Re: Variance Requests, 176 Scraggy Neck Road, Bourne (Map 51.0, Parcel 1)

**1. The variance application does not accurately describe Project’s impacts, because it fails to list any setback distances to Coastal Bank #3.**

# Exhibit A

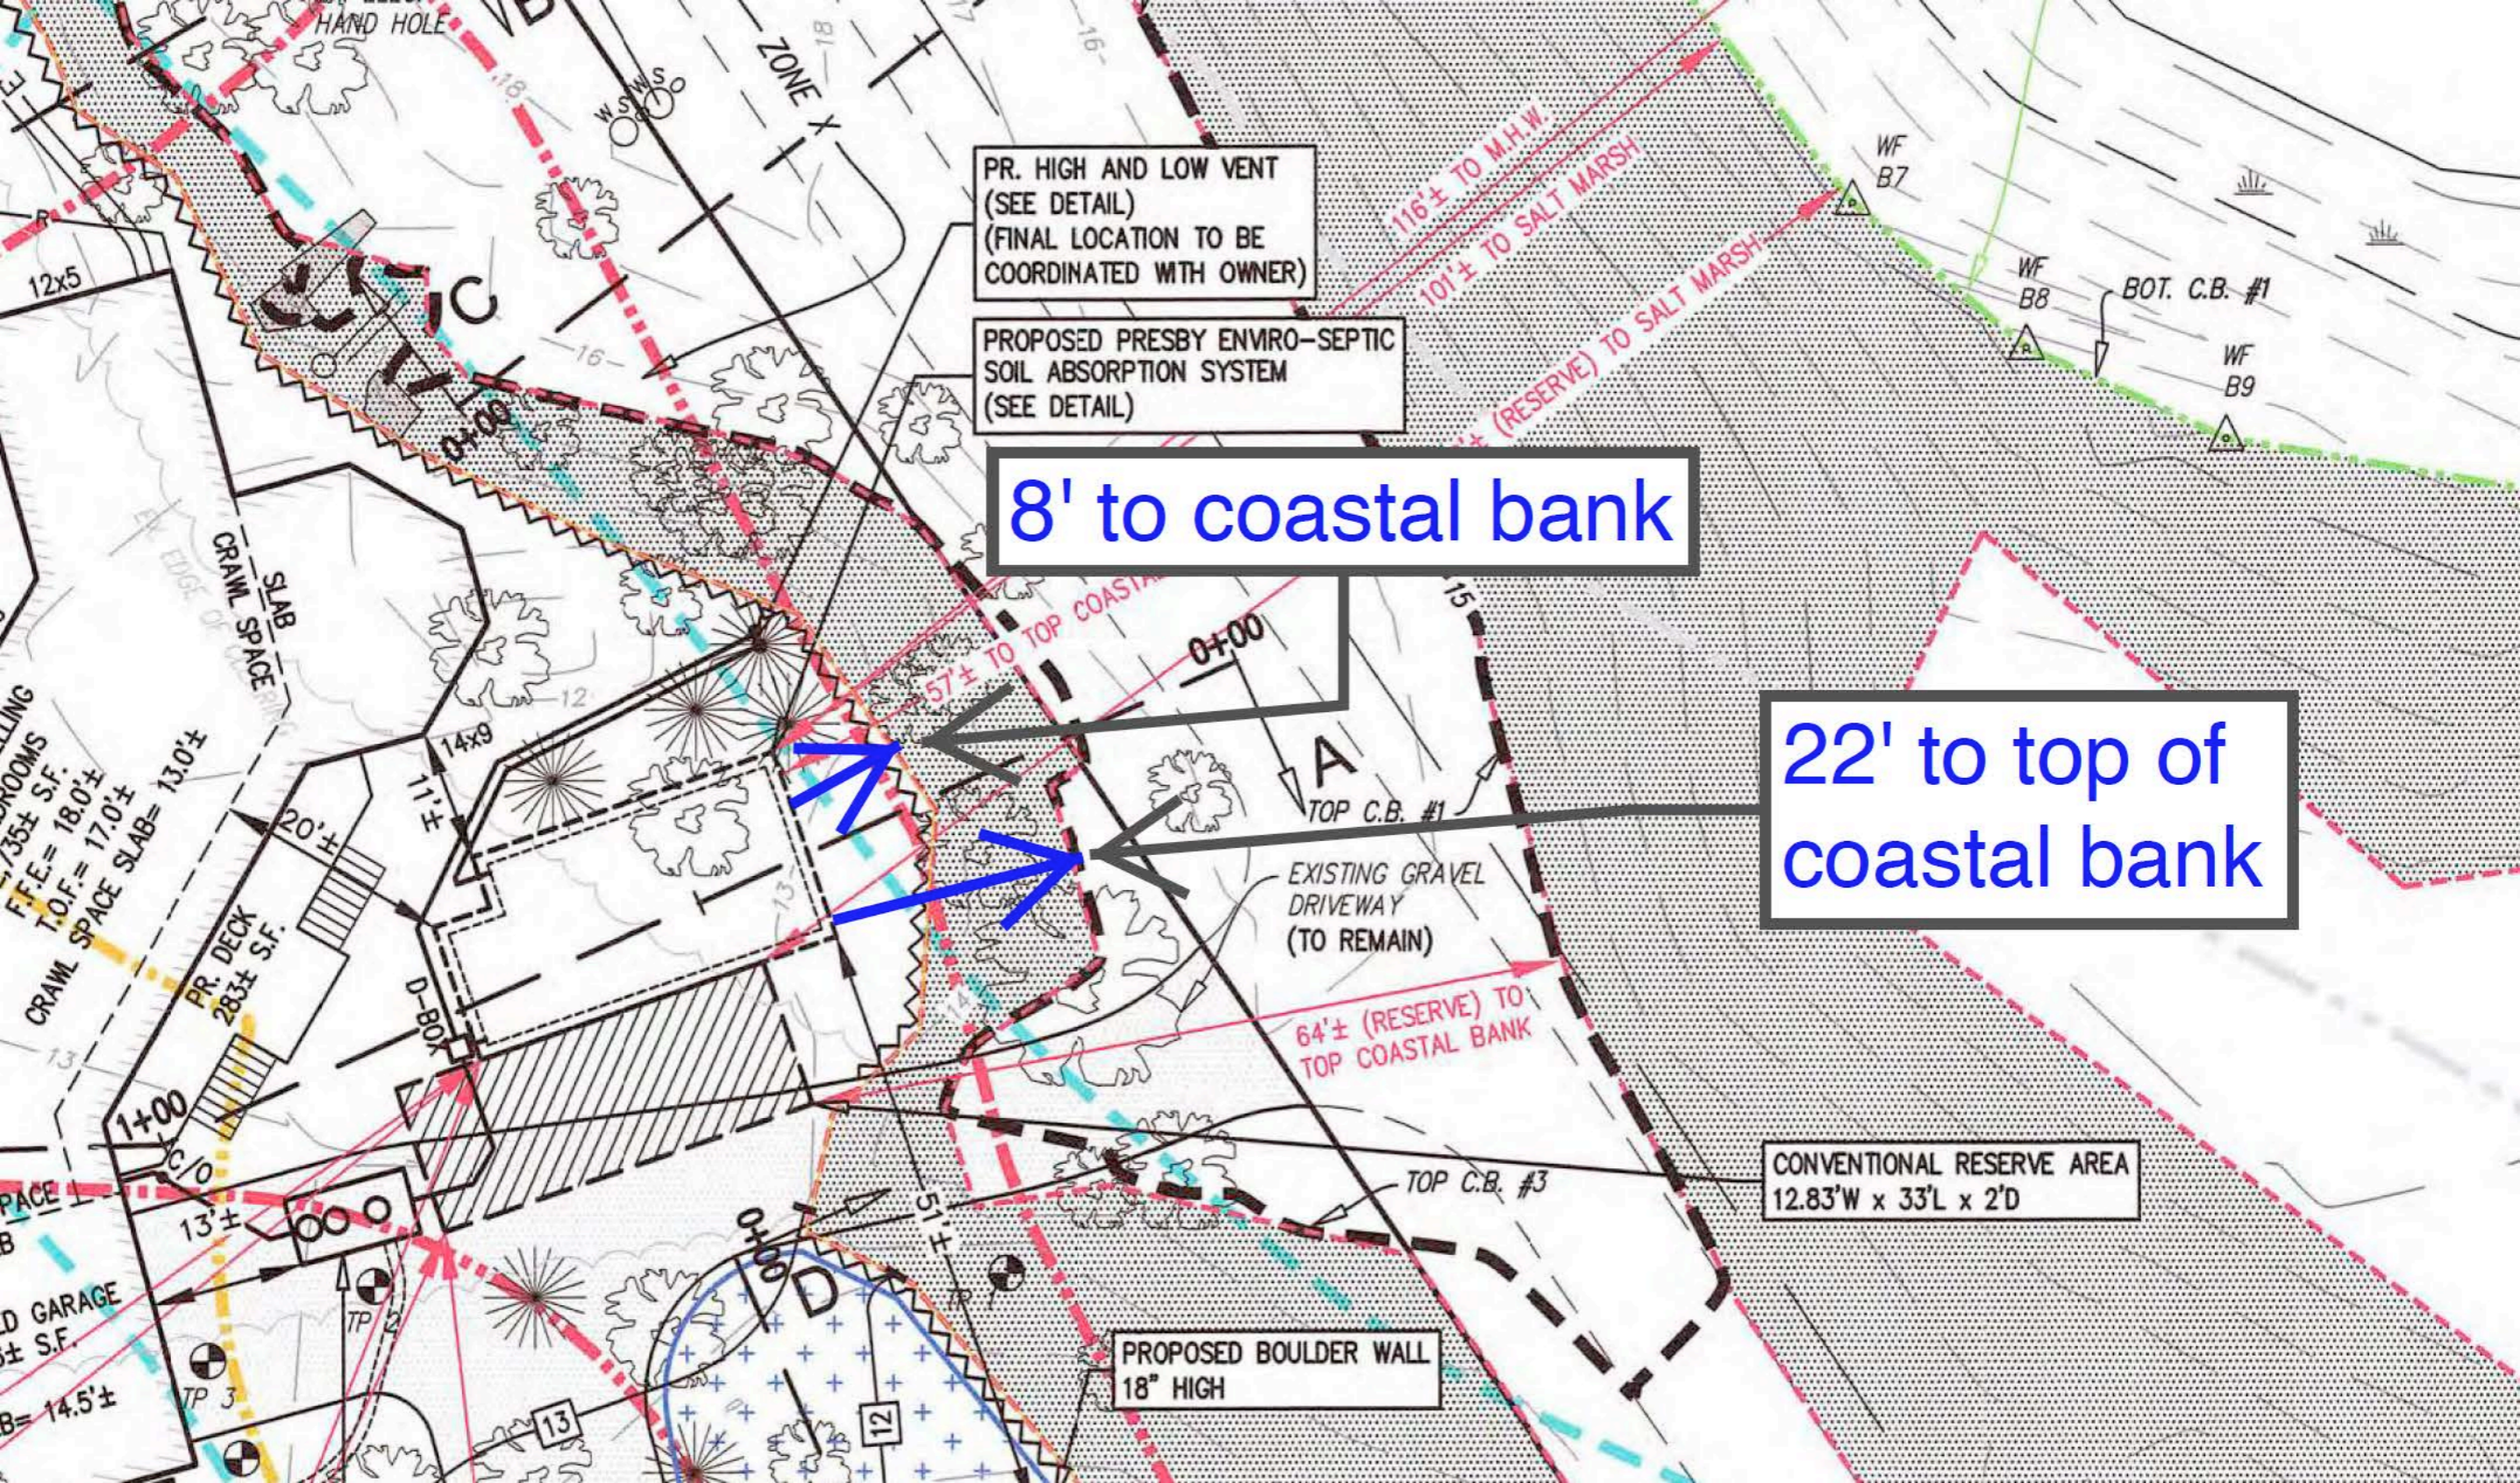
BEI’s variance application is inaccurate and fails to account for all Project impacts, because it does not include *any* setback distances to Coastal Bank #3, which is the closest Coastal Bank to the proposed septic system. To illustrate this deficiency, I have attached a map (Exhibit A) prepared by our expert hydrologist, Scott Horsley, which shows the setbacks from the top of Coastal Bank #3 to the proposed septic system. As shown on Exhibit A, the leaching field is only 8 feet from the bottom and 22 feet from the top of Coastal Bank #3, and the reserve area is even closer. Accordingly, the variances needed and the setback distances listed by BEI in the application are incomplete.

- As stated above, BEI’s application does not include *any* variance requests for setback distances to Coastal Bank #3, which is the closest Coastal Bank to the proposed septic system. As shown on Exhibit A, the proposed leaching field is only 8 feet from the bottom and 22 feet from the top of Coastal Bank #3. Coastal Bank #3 was confirmed by the Conservation Commission to be a Coastal Bank Wetland Resource Area, and it requires the same setbacks and consideration as the other Resource Areas on the Site.

The Project also requires variances from the state Title 5 regulations, because the proposed septic system is only 22 feet away from the top of Coastal Bank #3. Pursuant to the provisions of Title 5, 310 CMR 15.211(3) for "Minimum Setback Distances": "All setback distances from wetlands shall be measured in accordance with the criteria of the Wetlands Protection Act and 310 CMR 10.00: Wetlands Protection, from the most landward edge of the following features: ... **top of coastal bank as defined in 310 CMR 10.30(2)**" (emphasis added). This means that under Title 5, a septic system must be located 50 feet from all Coastal Banks, measured from the top of the Coastal Bank. See 310 CMR 15.211(3). Where the Applicant has failed at this point to even acknowledge that Title 5 applies here, and has not applied for any Title 5 variances, we request that the Board reject the current application.
